PROJECT: 2023/2024 Westwood Area Reconstruction – Re-Bid

ADDENDUM NO. 1: Bid Documents for this project are being modified, supplemented, clarified or augmented as follows as part of this addendum. All revisions will hereby be made a part of the proposed Contract Documents.

**CITY OF HILLSDALE  
SPECIAL PROVISION  
FOR  
TEMPORARY PAVEMENT**

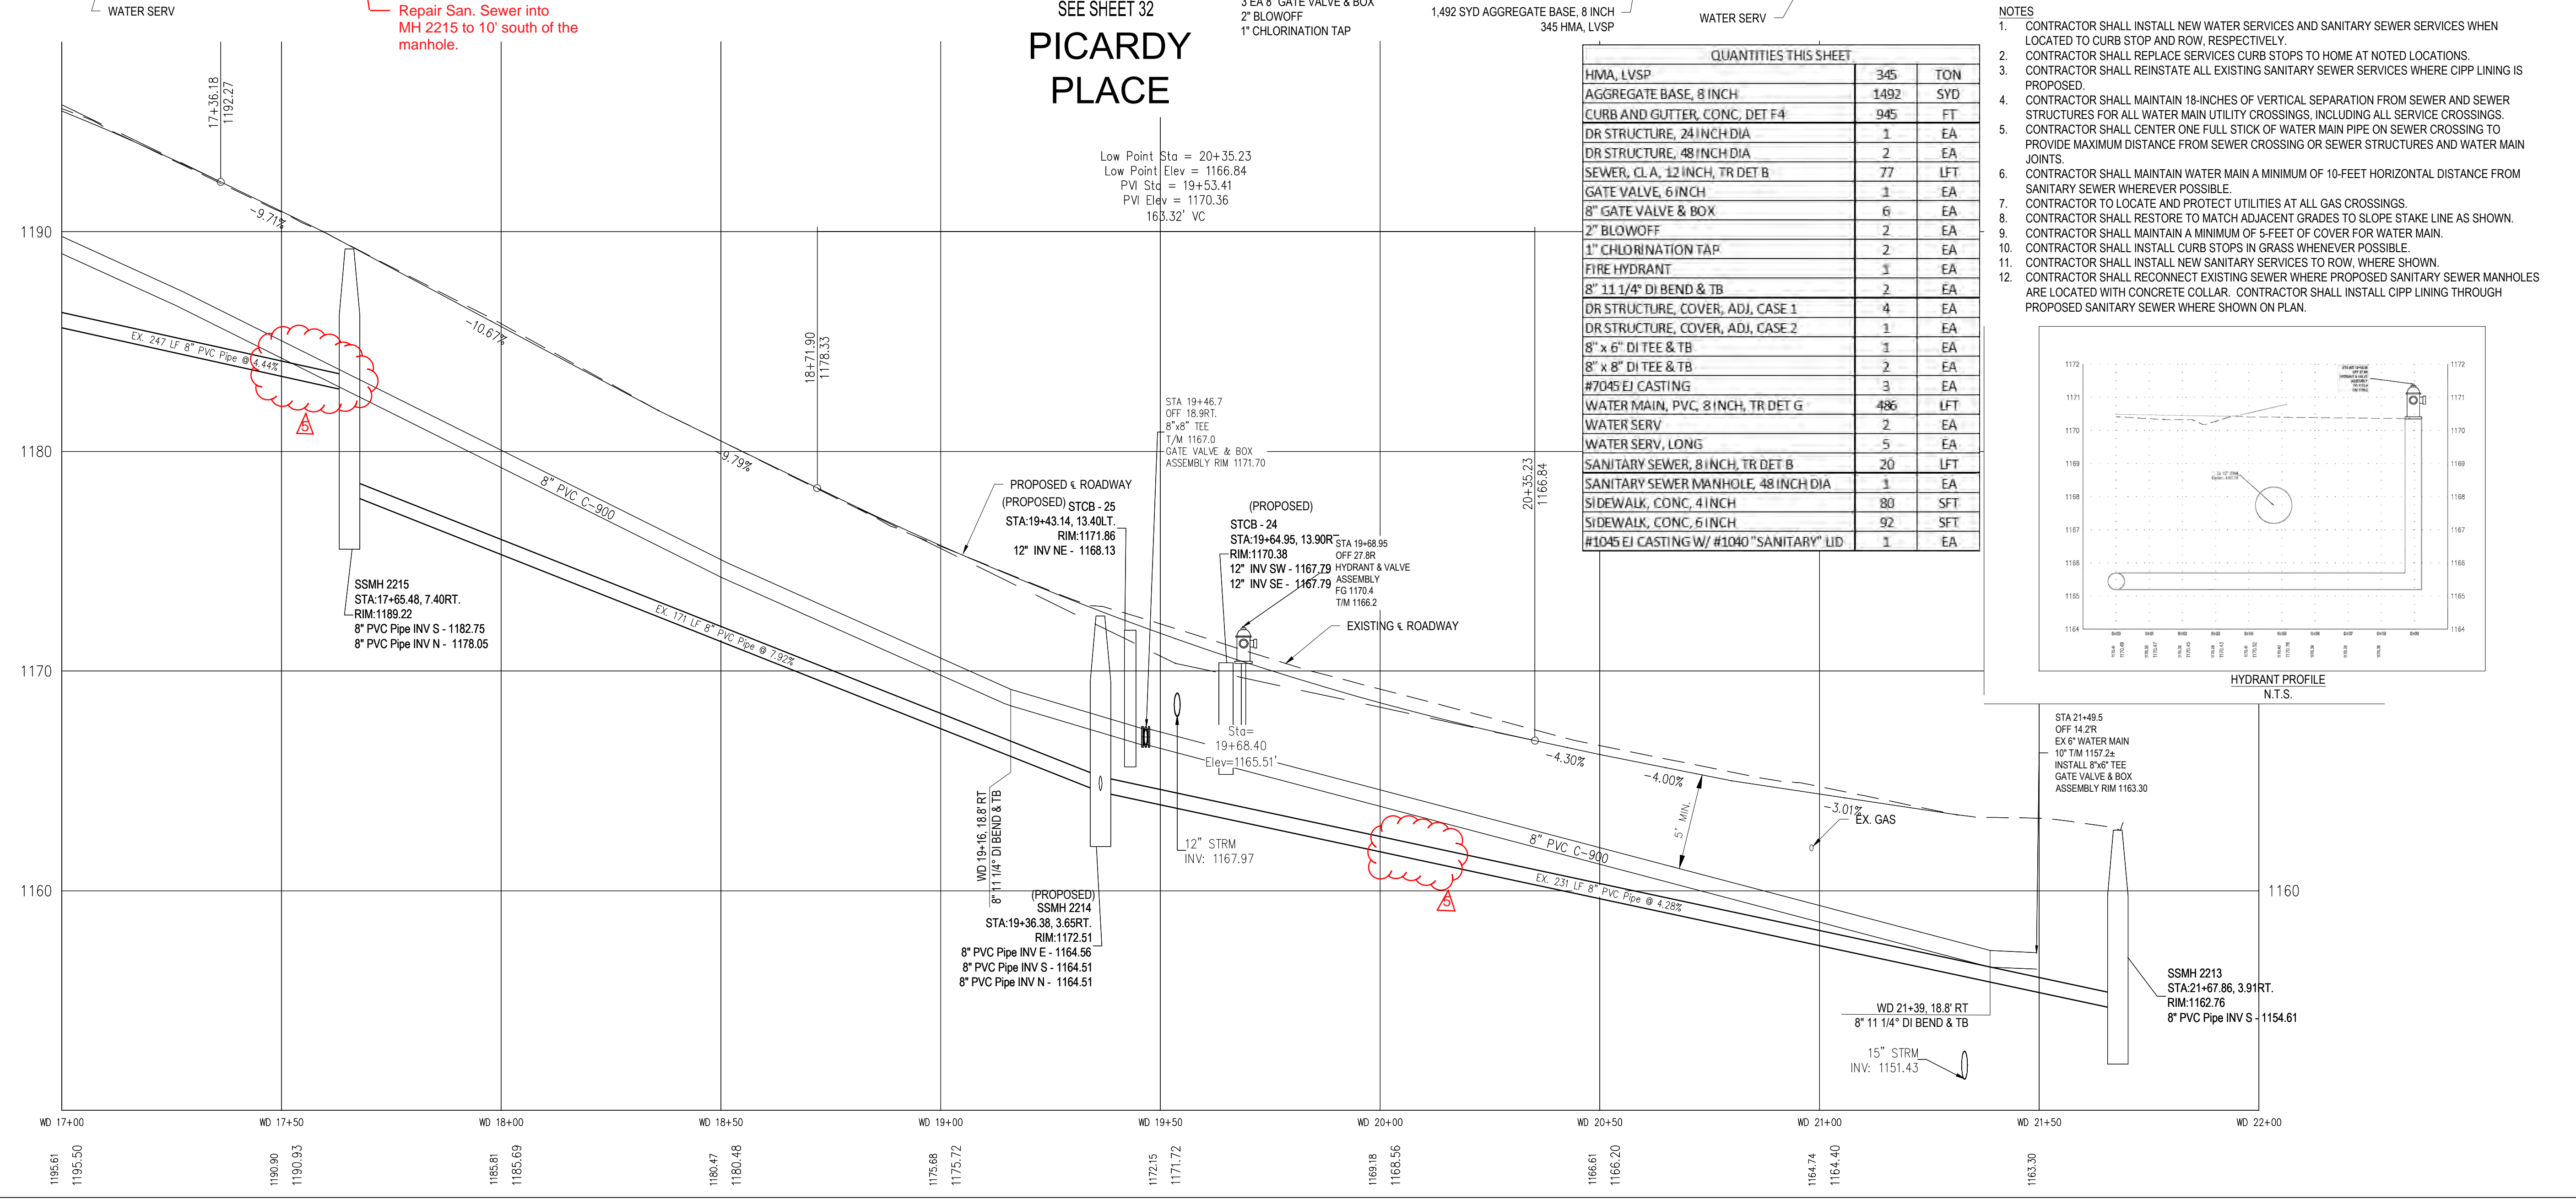
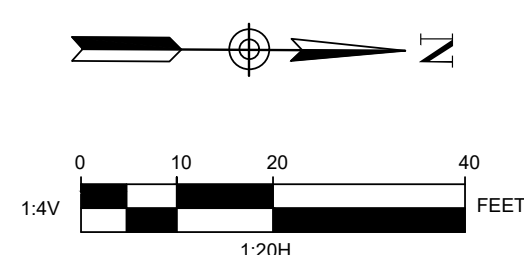
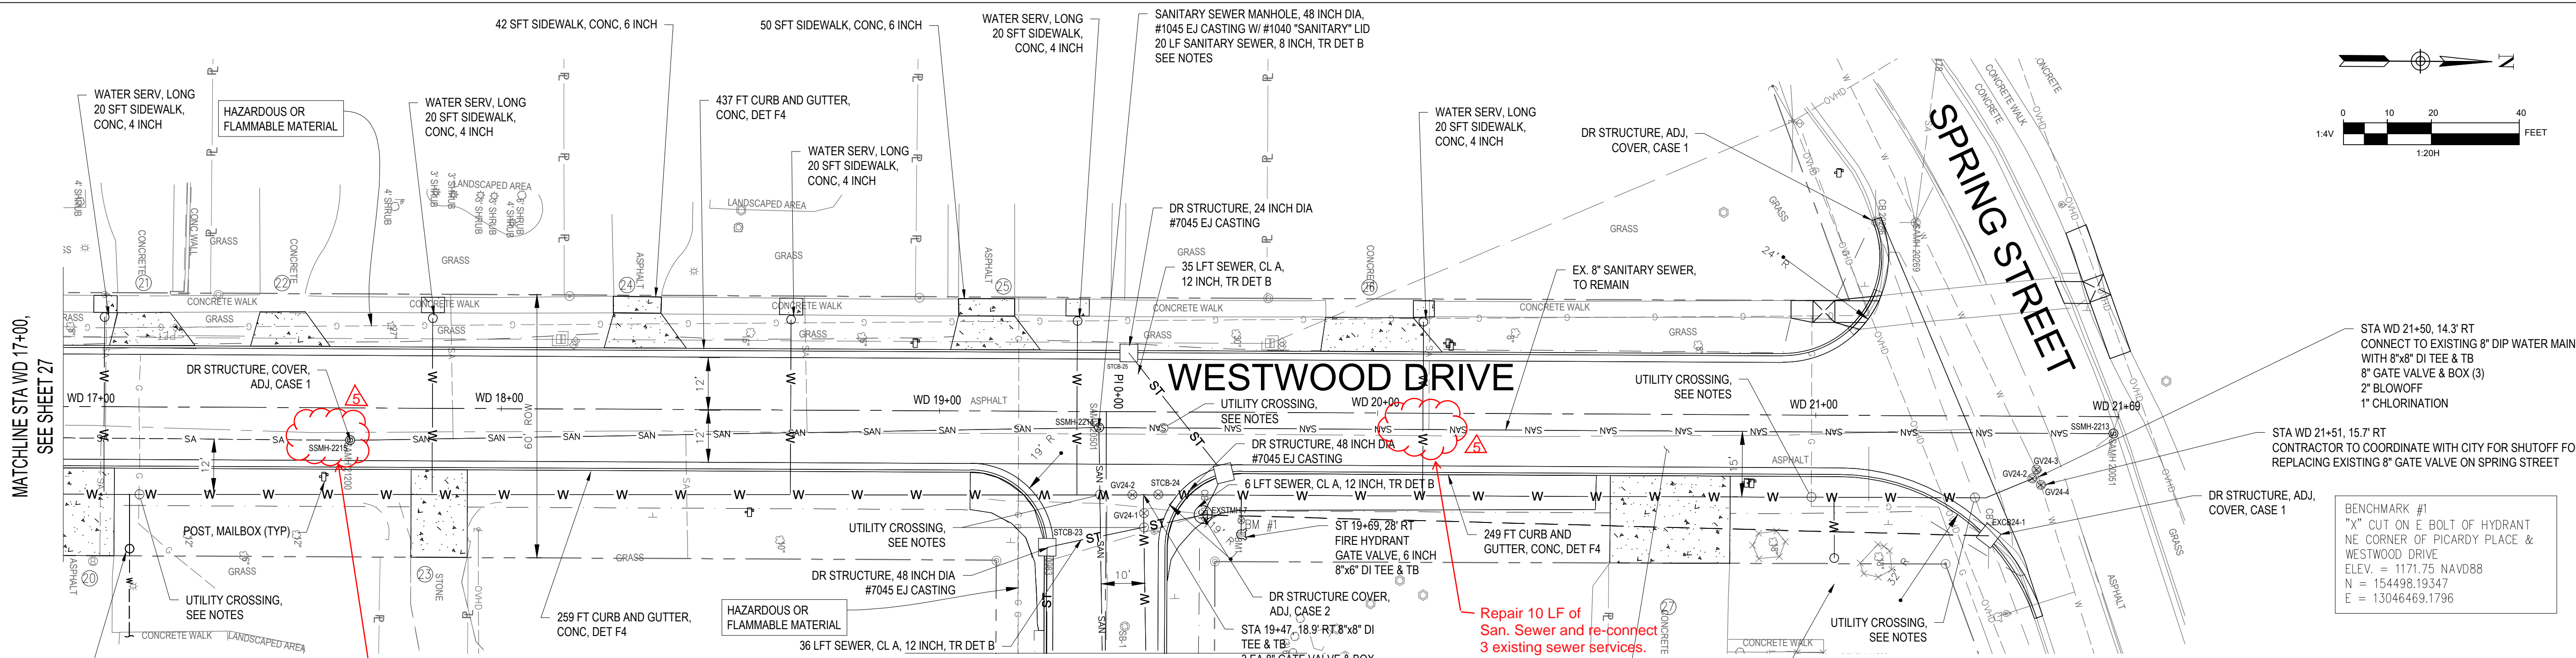
2. Temporary Pavement Options. The HMA pavement section consists of one 2-inch lift of 13A HMA.

3. Temporary Base Material. The temporary base material for the temporary pavement shall be 10" of compacted material from the existing roadway, as approved by the Project Engineer.

**WESTWOOD DRIVE PLAN & PROFILE**  
Sta. WD 17+00 to  
Sta. WD 21+34

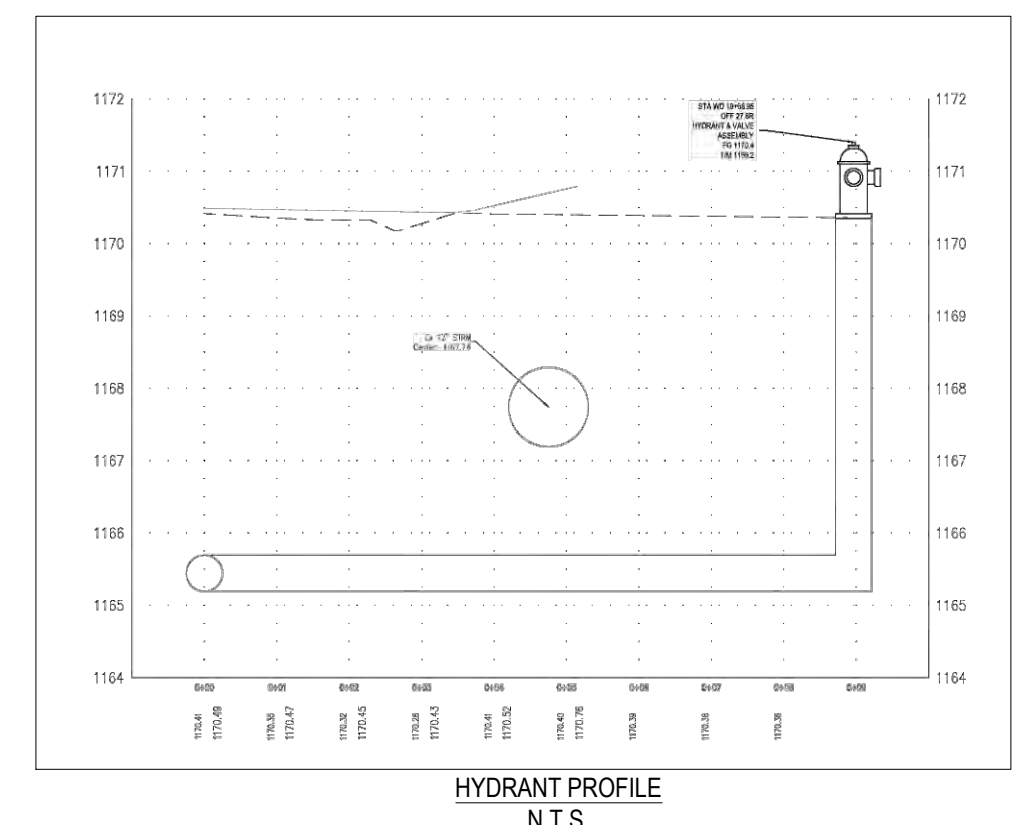
MODIFICATION NO.	SUMMARY
1	Reissued Proposal Page 11 to be replaced by Page 11 Add 1 with the following changes: <ul style="list-style-type: none"><li>a. Increase Item 4027002 Service Lateral, 4 Inch, SDR 35 to 27 EA. The area noted for repairs, shown on reissued Project Drawing 28, contains 3 additional sewer services to be re-connected during the repair of the sanitary sewer.</li><li>b. Increase Item 4037001 Sanitary Sewer, 8 Inch, Tr Det B to 1474 LFT. Refer to reissued drawing page 28 for locations of additional repairs to be completed on the sanitary sewer system by open excavation.</li></ul>
2	Reissued specification page SP-68 to replace with page SP-68 Add 1 – Reissued to clarify that Pavt, Temp will be paid by the Square Yard <u>NOT</u> Tons, as highlighted.
3	Reissued Project Drawing 28 to show location of repairs required to be completed by open excavation. Each repair location will be approximately 10 feet in length at the depths shown in the sewer line profiles.
